Re: *Addendum No. 1*
Roosevelt Park – Bocce Court
City of Campbell

Date: April 8, 2020

CITY OF CAMPBELL
BOCCE COURTS AND PAVILION
CAMPBELL, OHIO
MAHONING COUNTY
PLANS AND DETAILS

ROOF PLAN
SCALE: 1/16" = 1'-0"

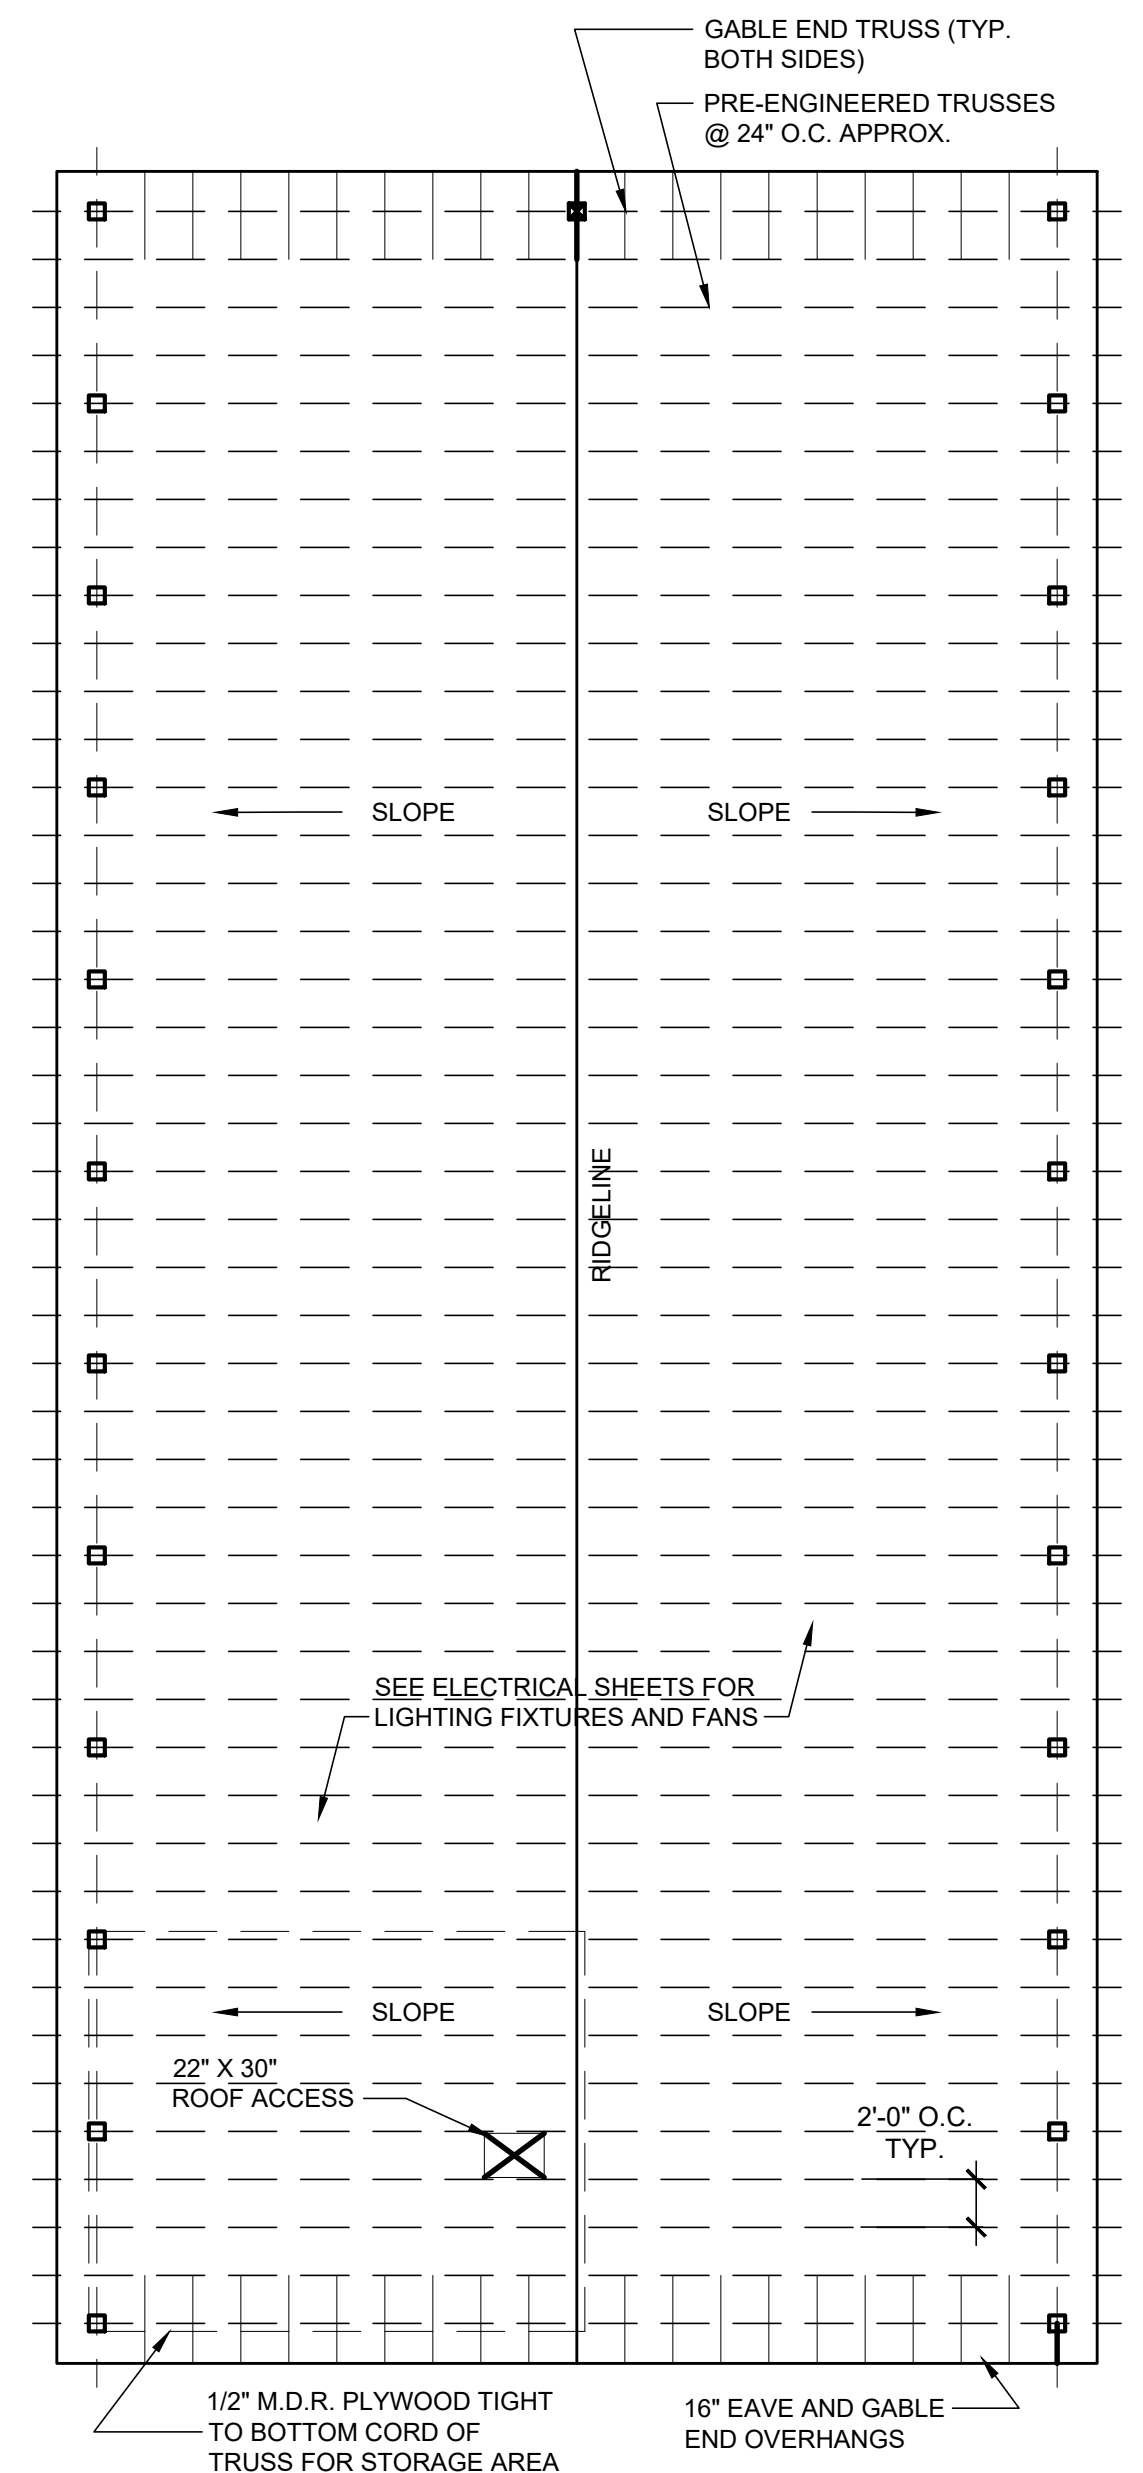
Delete and Replace: Drawing A-01, Plans and Details with revised sheet dated 4/2/2020.

ISSUED FOR:	BID	ISSUE DATE:	SCALE:	DESIGNED BY:	PAW	DRAWN BY:	PAW	CHECKED BY:	ADT
REVISIONS	DESCRIPTION	DATE	REVISIONS	DESCRIPTION	DATE	REVISIONS	DESCRIPTION	DATE	REVISIONS
1	ADDITIONAL 1 - COURT DETAIL CLARIFICATION	4/22/2020
